SB, Visor issue, PE 10H SmartGuard, 2023-10

Fig. 1: Visor is not staying in upright position.

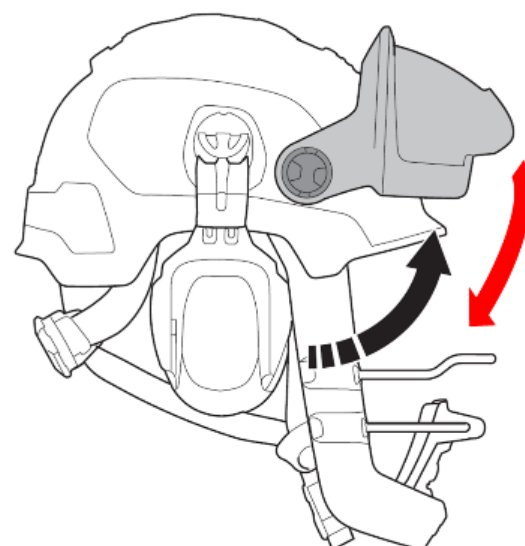
Visor on PE 10H SmartGuard helmet is not staying in the upright position (figure 1).

Check local inventory and recently sold units of PE 10H SmartGuard with the affected article numbers. If a faulty unit is found, replace the visor adapters (right and left).

Fig. 2: Replace the two visor adapters on a faulty unit.

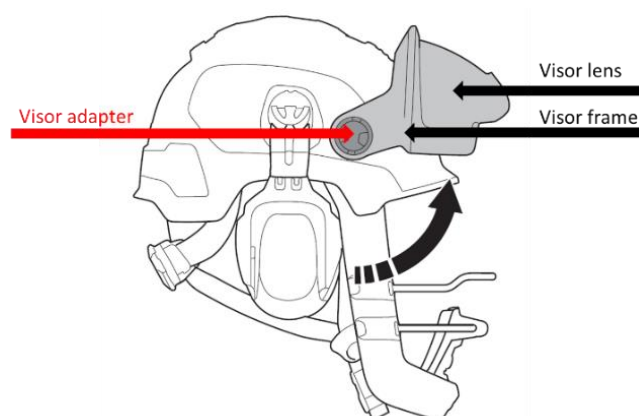
Article number 547161301 is a kit containing both the right and left adapter (figure 2).

Check if the adapter is working or not by putting the visor in the upright position. If the visor is not staying in the upright position, replace the visor adapters with spare part:

- Adapter kit PE10H: 547161301
